TOWN OF NEWBURGH PLANNING BOARD TECHNICAL REVIEW COMMENTS

PROJECT NAME:SHOPPES AT UNION SQUARE PHASE IIIPROJECT NO.:23-16PROJECT LOCATION:1217 & 1219 ROUTE 300SECTION 96, BLOCK 1, LOT 6.2 & 11.11REVIEW DATE:7 AUGUST 2024MEETING DATE:15 AUGUST 2024PROJECT REPRESENTATIVE:KARC PLANNING CONSULTANTS

RE: 1217 & 1219 NYS Route 300
 Parcel ID# 96-1-6.2 & 96-1-11.1
 Newburgh Shoppes Phase III - Site Plan / Subdivision Applications

WB-50 IN FROM ORR AVENUE

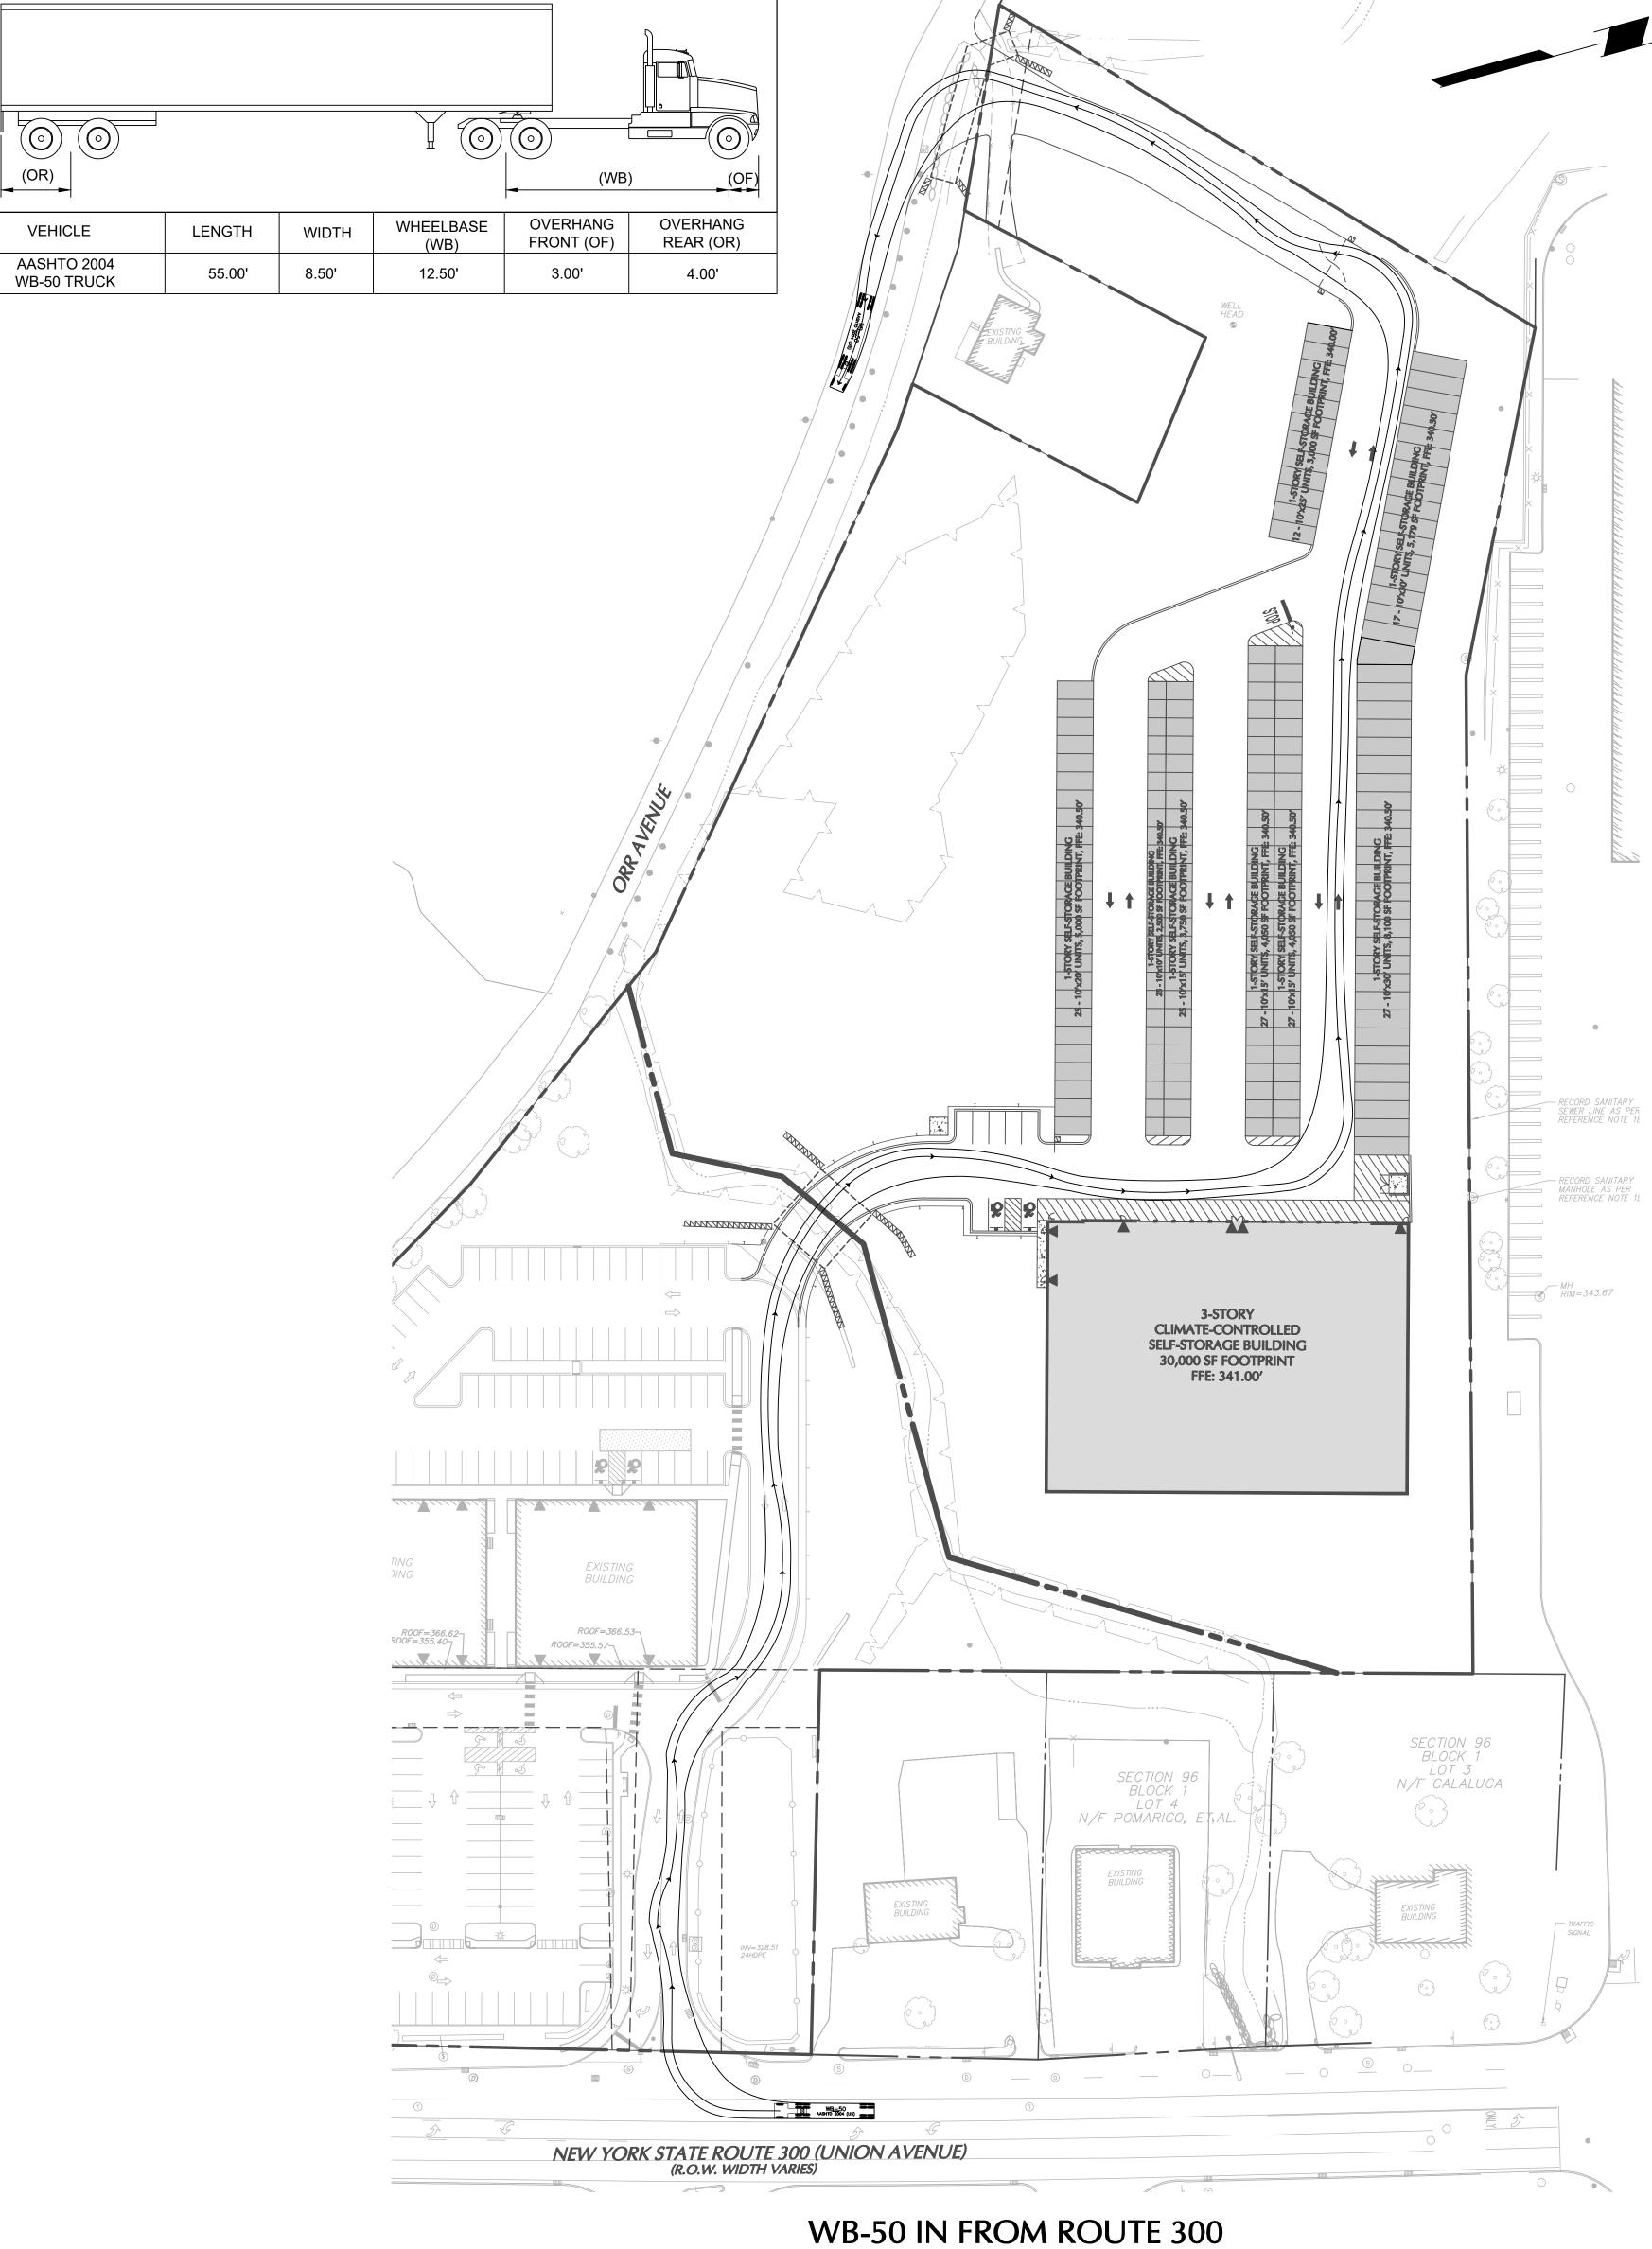
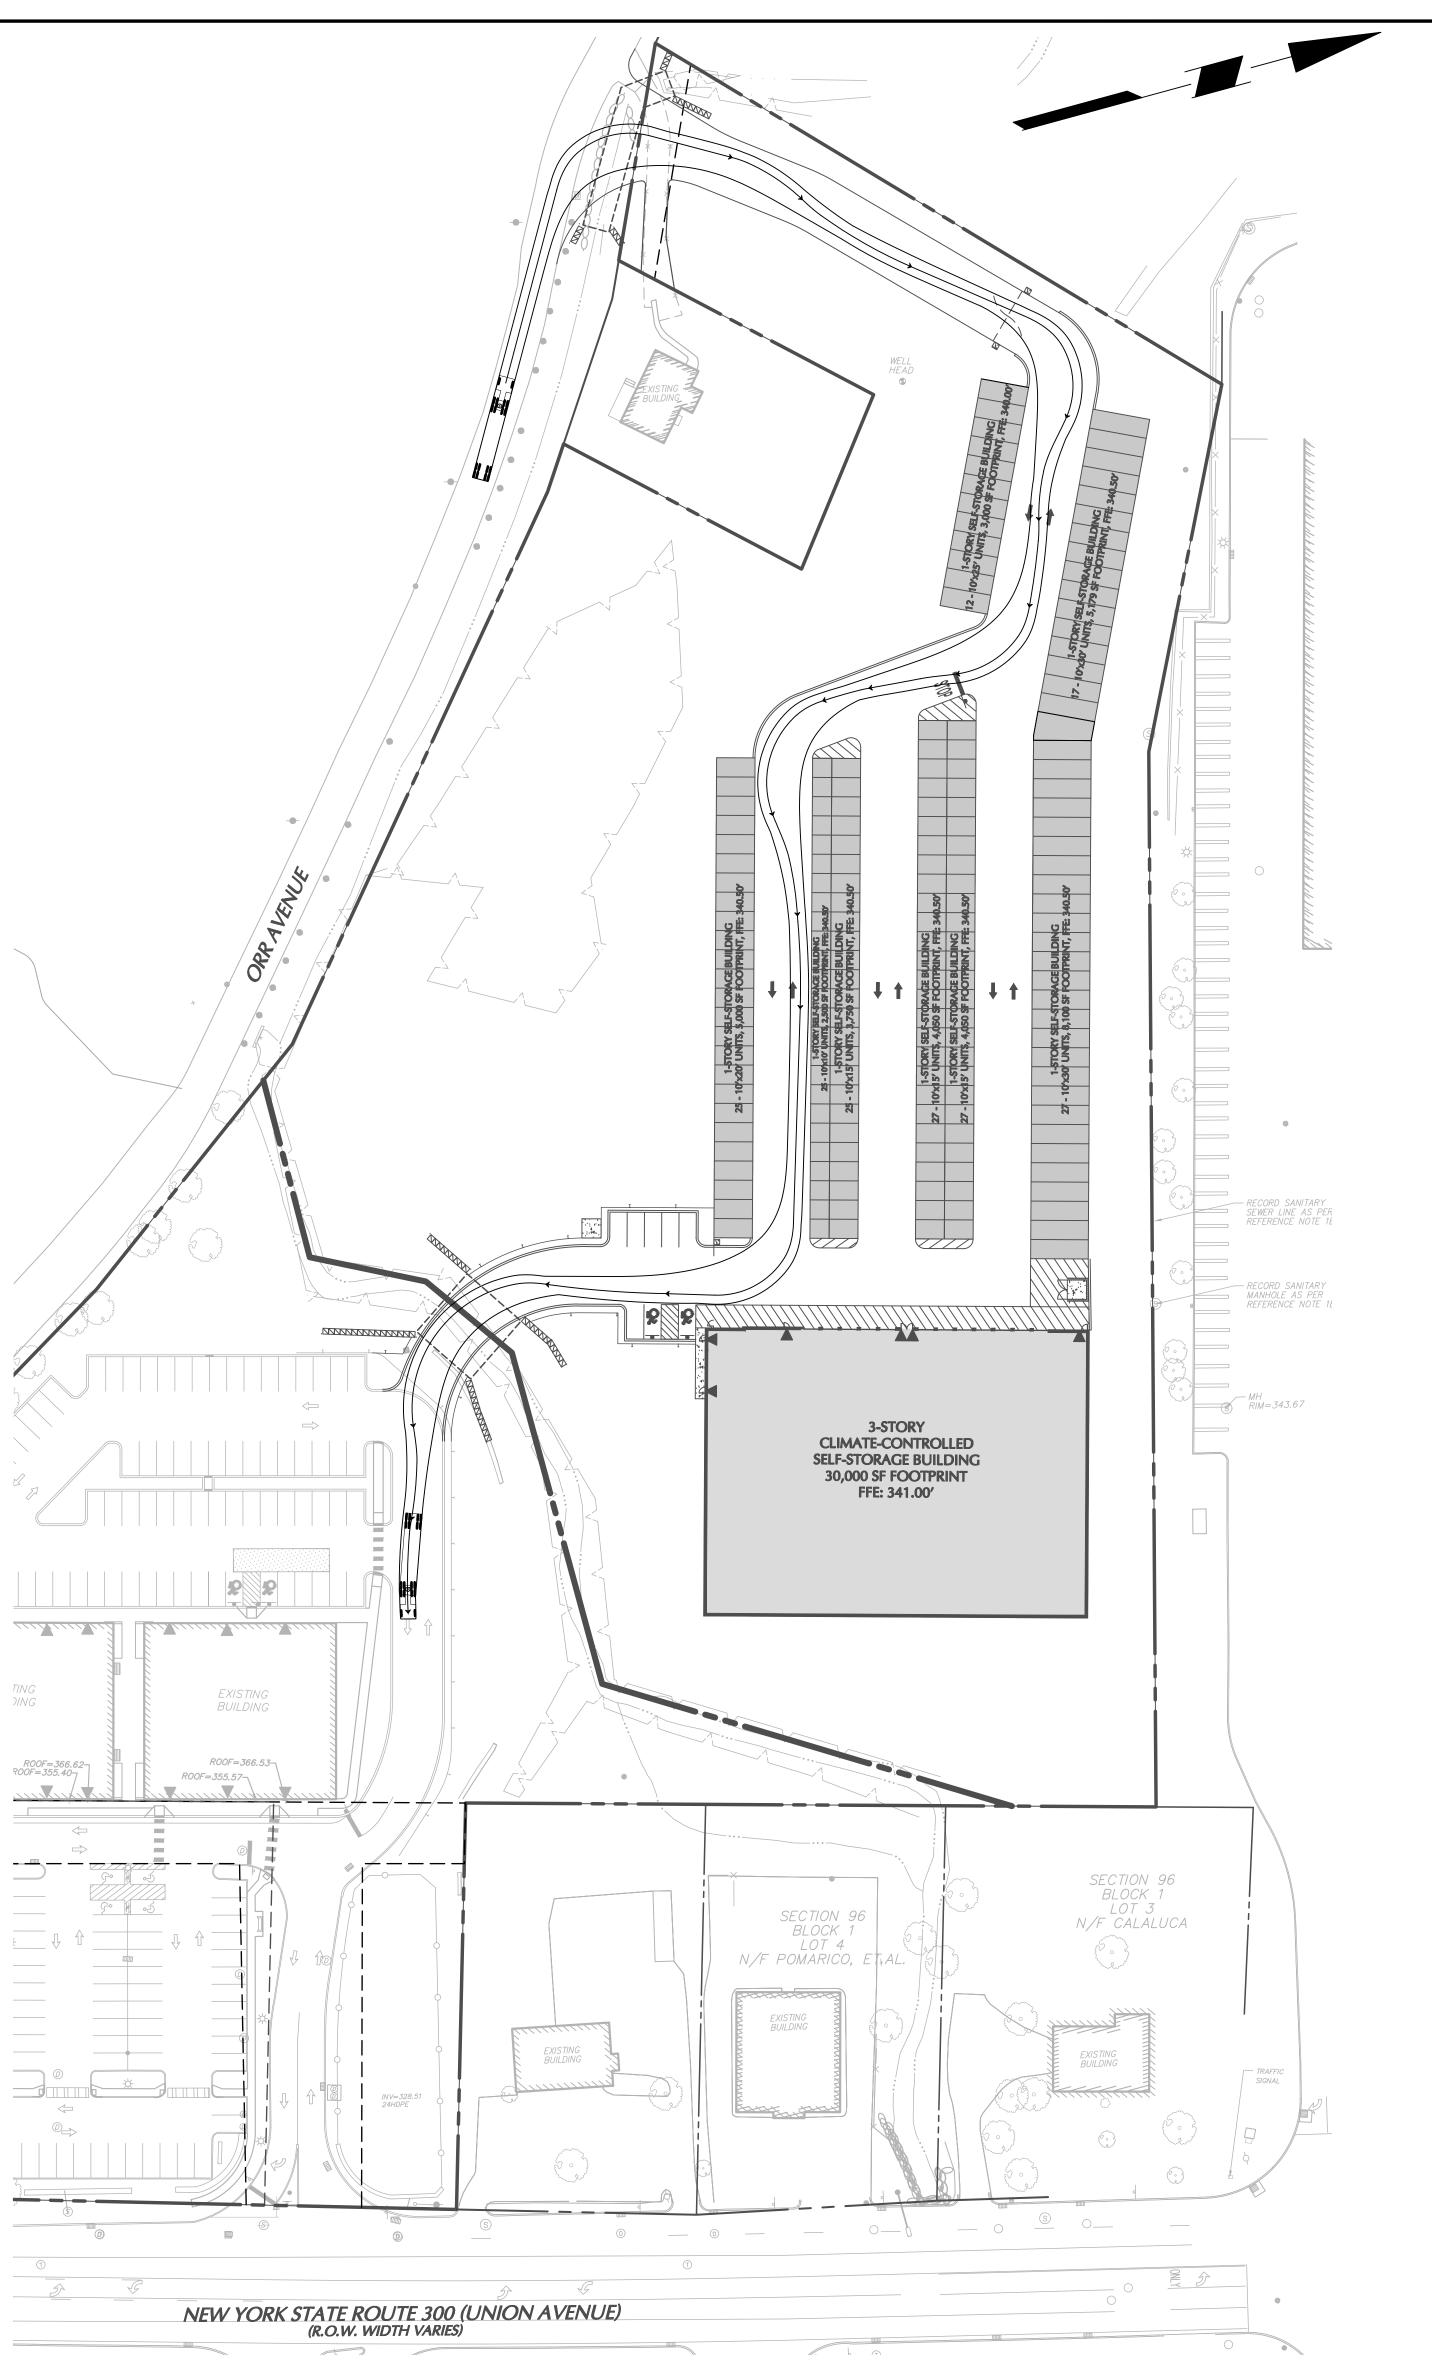
2. Truck turning movements should be shown on future plans.

<u>Response</u>: Please see Truck Turning Analysis Plan (Sheet 20.15) and Fire Truck Turning Analysis Plan (Sheet 20.14) prepared by Langan Engineering dated July 26, 2024 included in this submission.
